Addendum #	02	Date Issued	03/31/2025
Project Name Job #	SWN 0509, Waneta Hall Renovate Restrooms	OSE # R0325--15X	EAPC #20256780
Bid Date Time	April 3, 2025		3:30pm

THIS ADDENDUM AMENDS AND BECOMES PART OF THE CONTRACT DOCUMENTS FOR EAPC PROJECT 20246780 DATED 03/13/2025, RESPECTIVELY. EACH BIDDER SHALL ACKNOWLEDGE RECEIPT OF THIS ADDENDUM BY MARKING THE ADDENDUM NUMBER AND DATE ON THE BID FORM.

FINISH PLAN - FIRST FLOOR - LAUNDRY / STUDENT SPACE (ADD ALT 2)
1/4" = 1'-0"

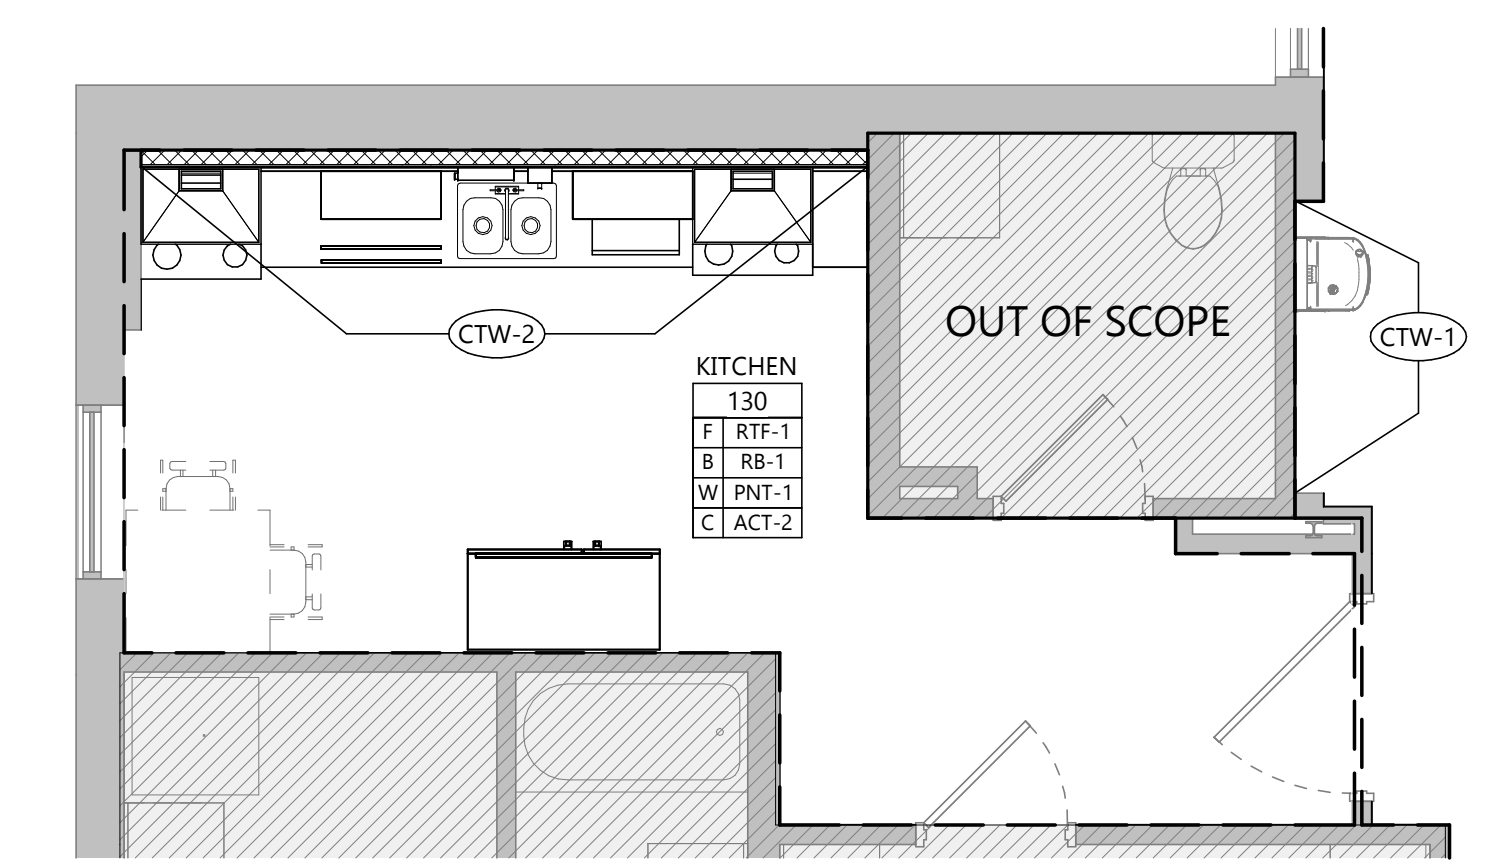
- A902 REVERSE Keynote AI 03.
CLARIFY paint finishes at General Finish Notes 5,17,19, and 22.
- A904 REVERSE Keynote AE 02 to AE 55.
ADD Keynote AE 55 and REVERSE AI 04 in Keynote Legend.
REVERSE finish transitions and CLARIFY room numbers at detail 1/A904.
CLARIFY paint finishes at General Finish Notes 5,17,19, and 22.

10 FINISH DETAIL - INTEGRAL COVE BASE AT CTW
A921 1 1/2" = 1'-0"

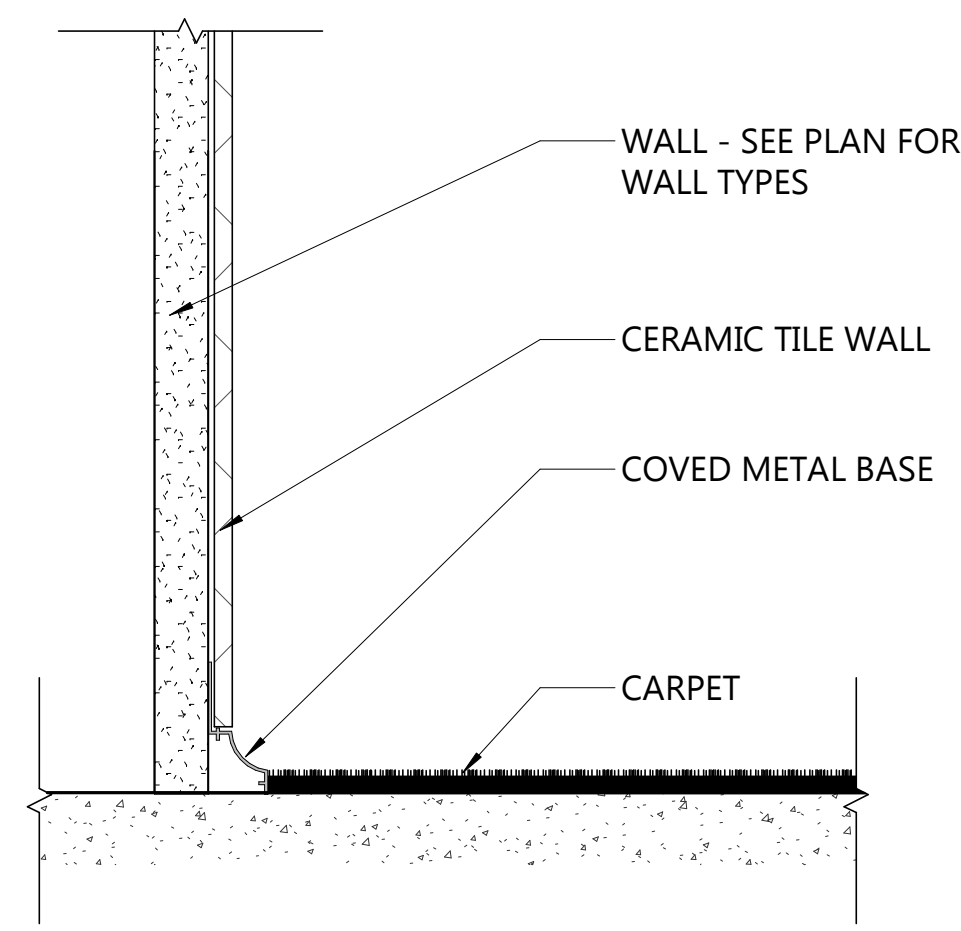
- A921 REVERSE detail 8/A921.
ADD details 9/A921 and 10/A921 in their entirety.
ADD finish CPT-5.
- M301 ADD General Note 01 regarding sealing annular space at all floor and ceiling penetrations between floors with noncombustible material to resist the passage of fire and smoke. Note 02 clarifies outdoor ductwork shall be pre-assembled phenolic type (see specification). ADD fire dampers at floor assembly between first and second floor as shown on plan.

M302

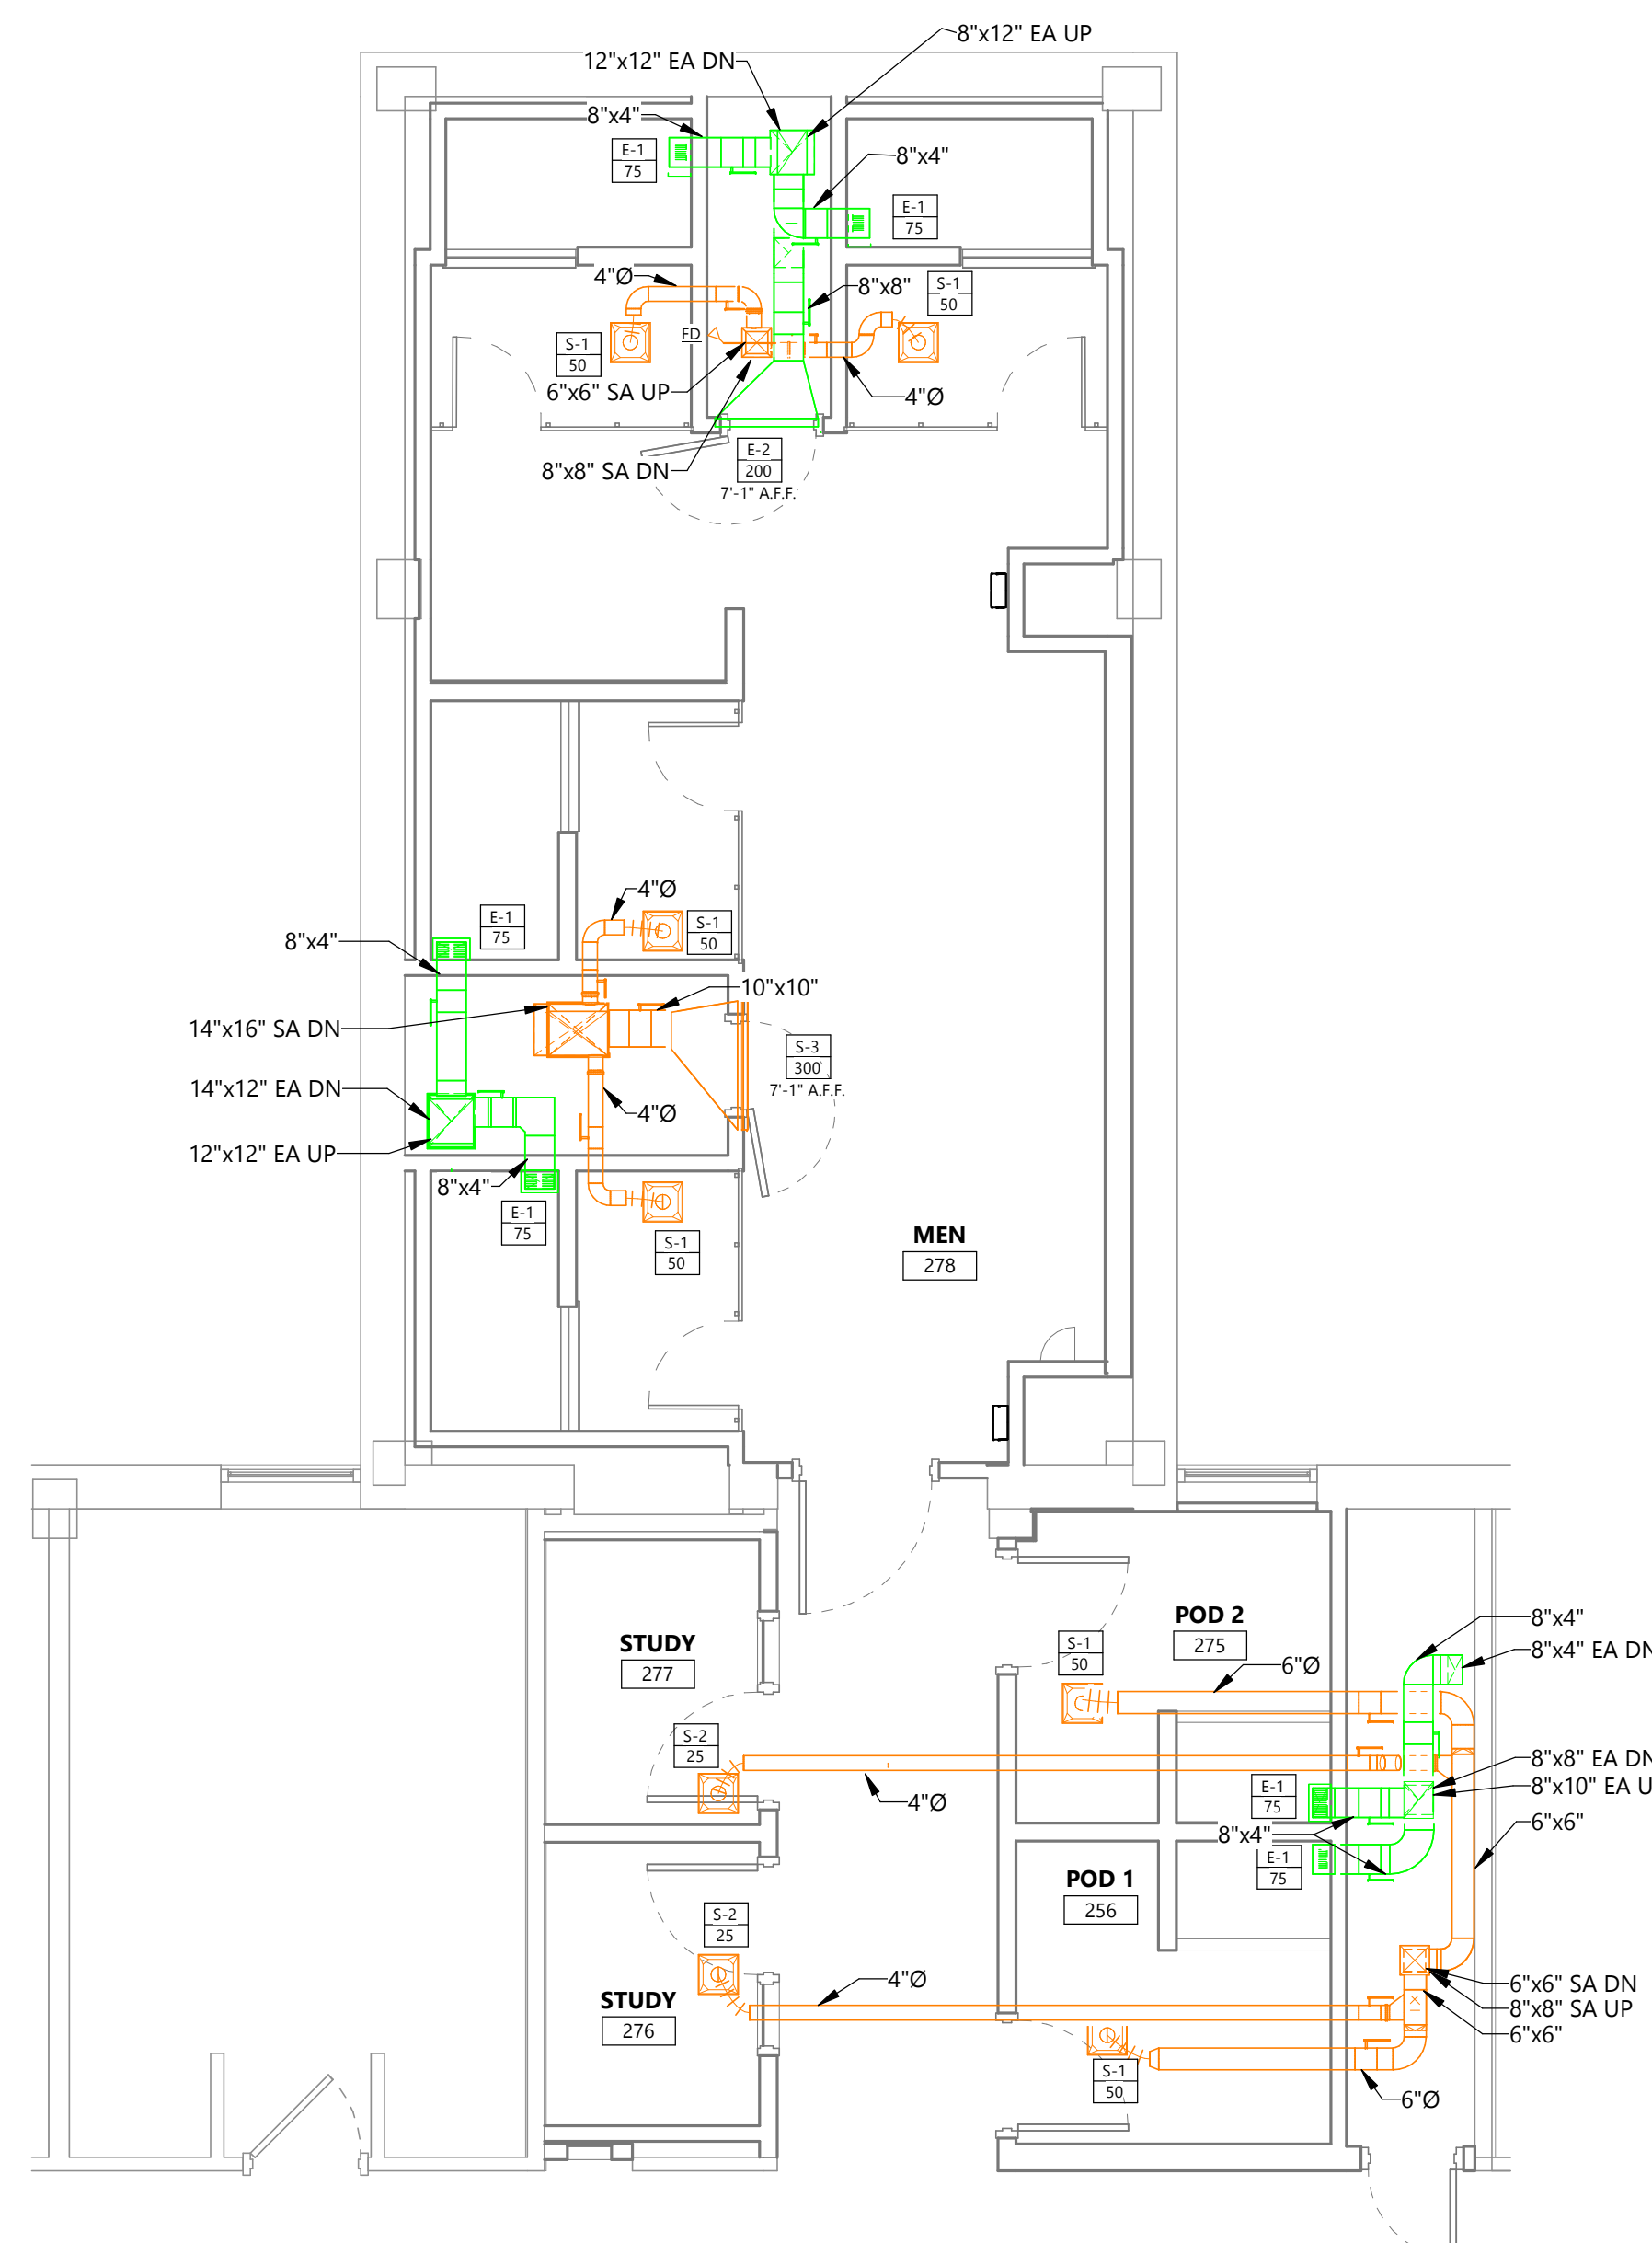
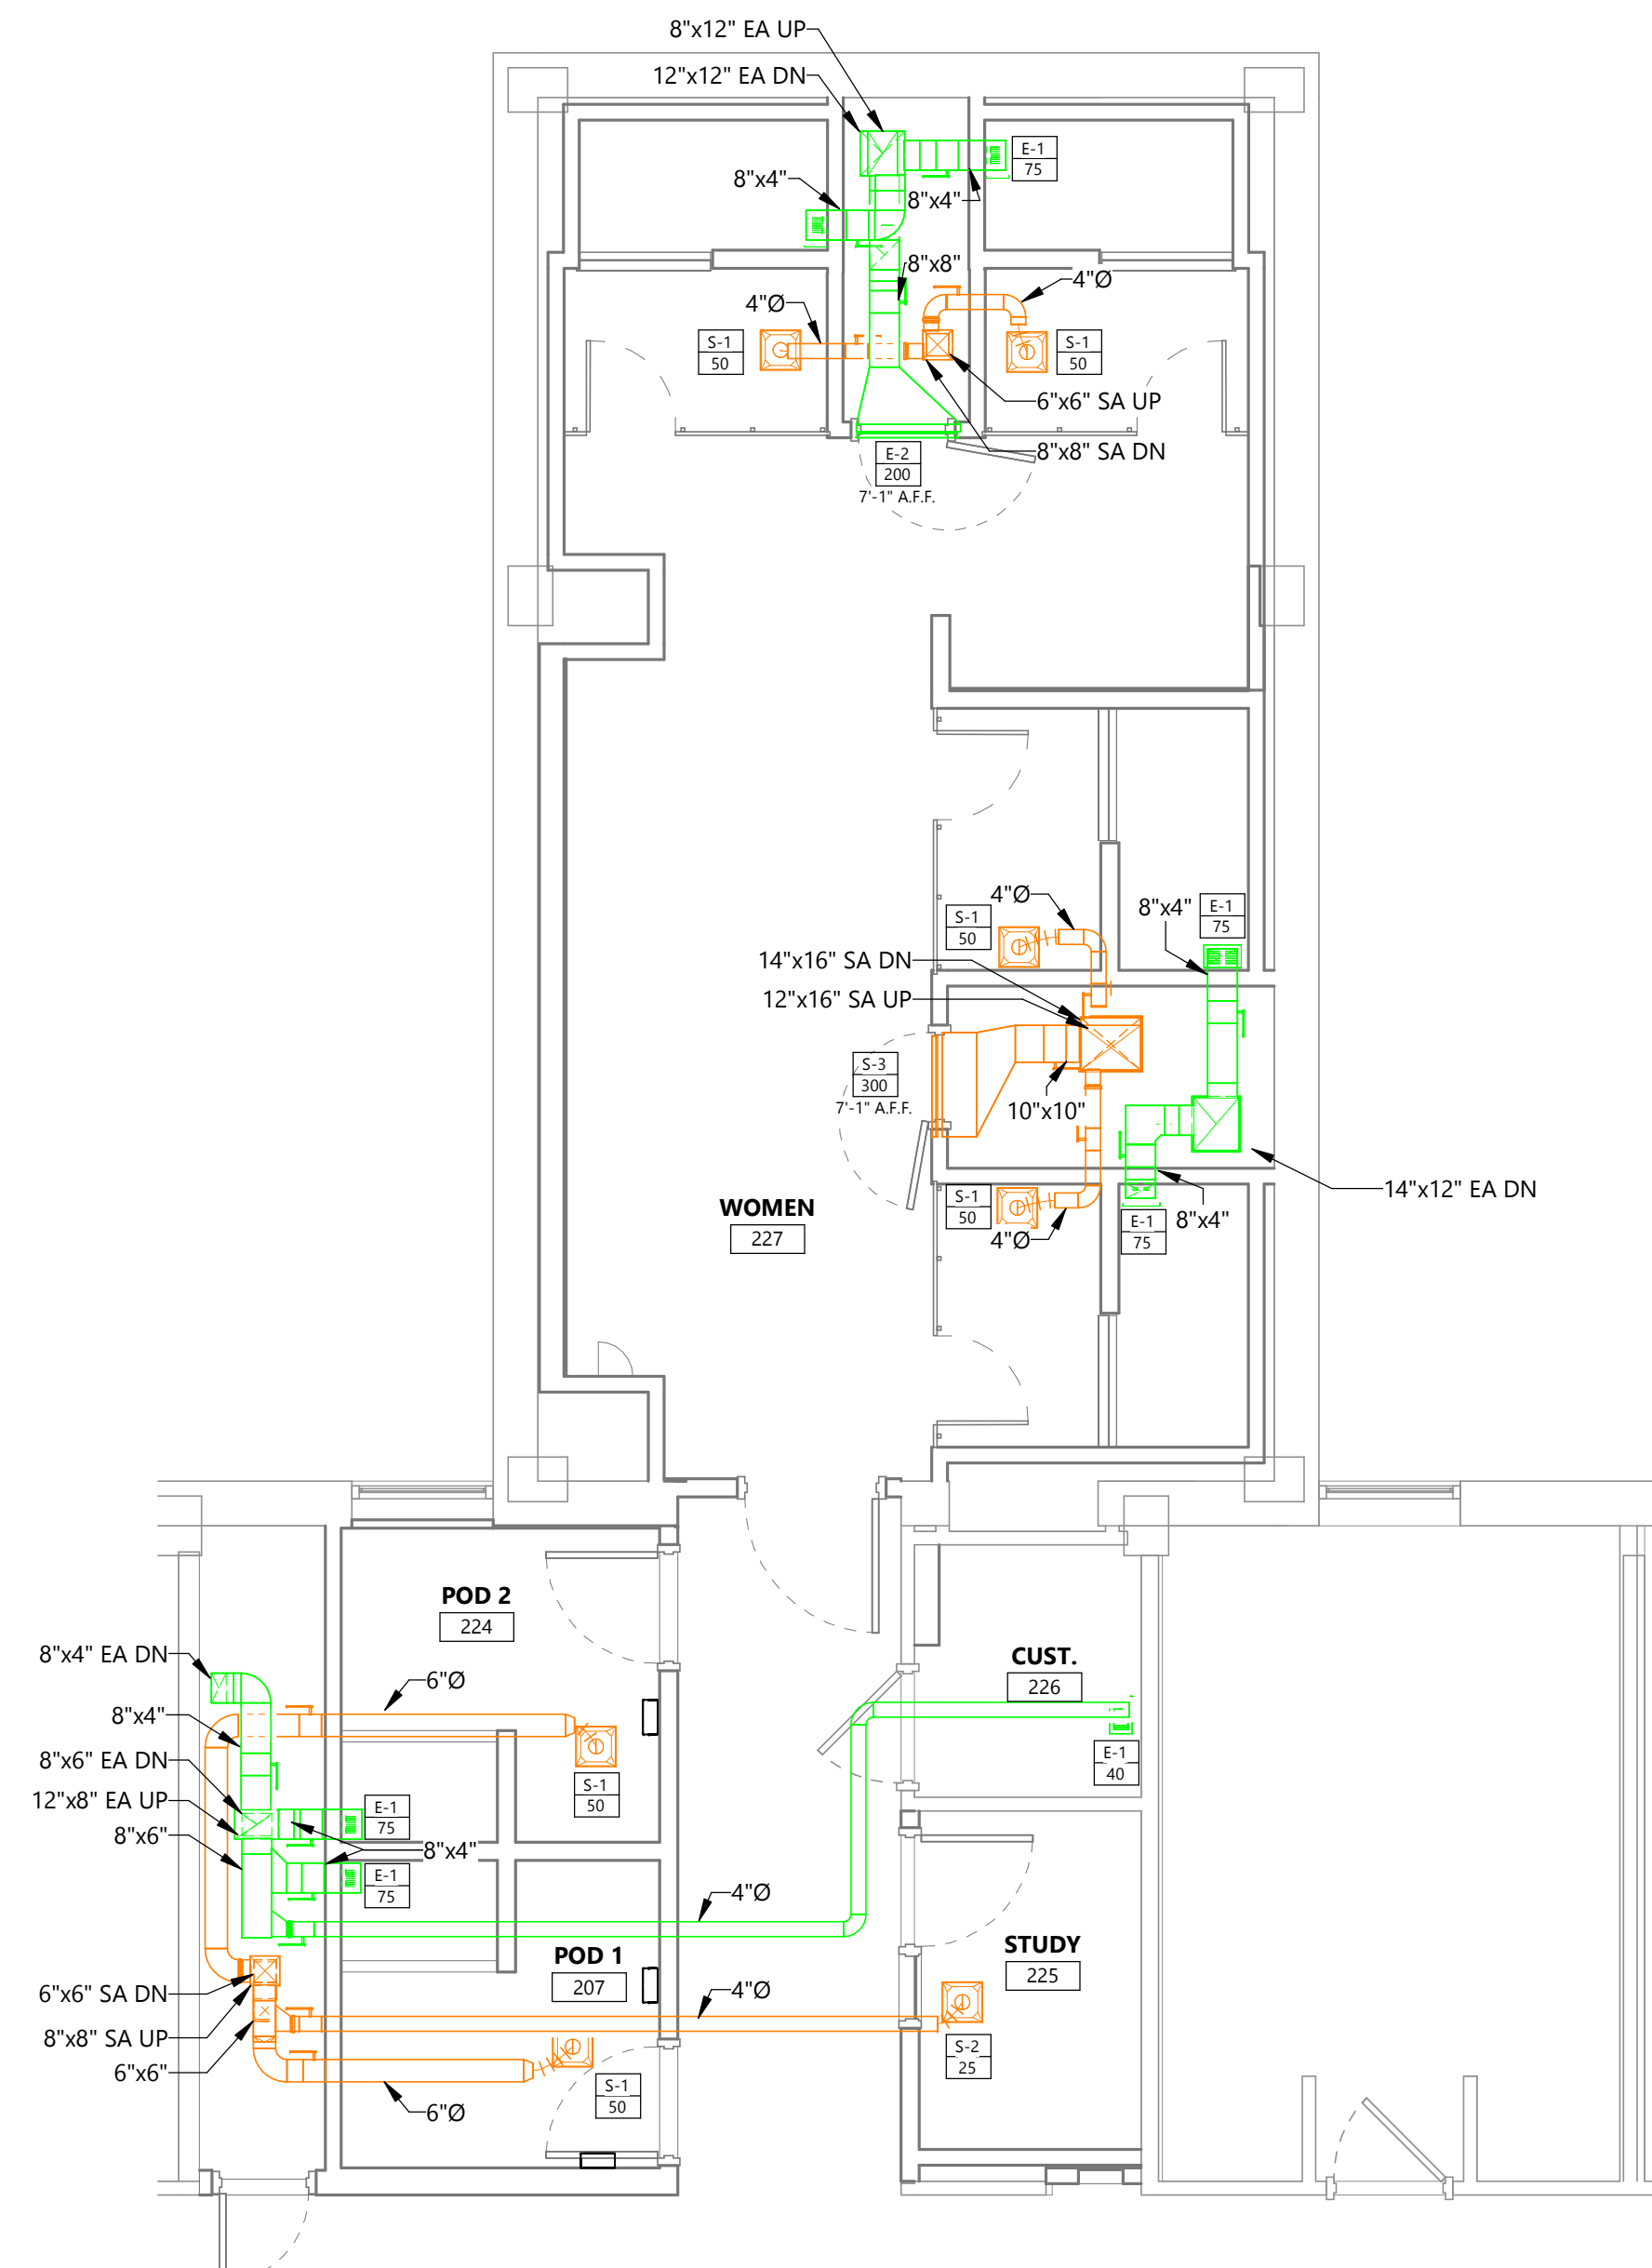
- M302 ADD General Note 01 regarding sealing annular space at all floor and ceiling penetrations between floors with noncombustible material to resist the passage of fire and smoke.
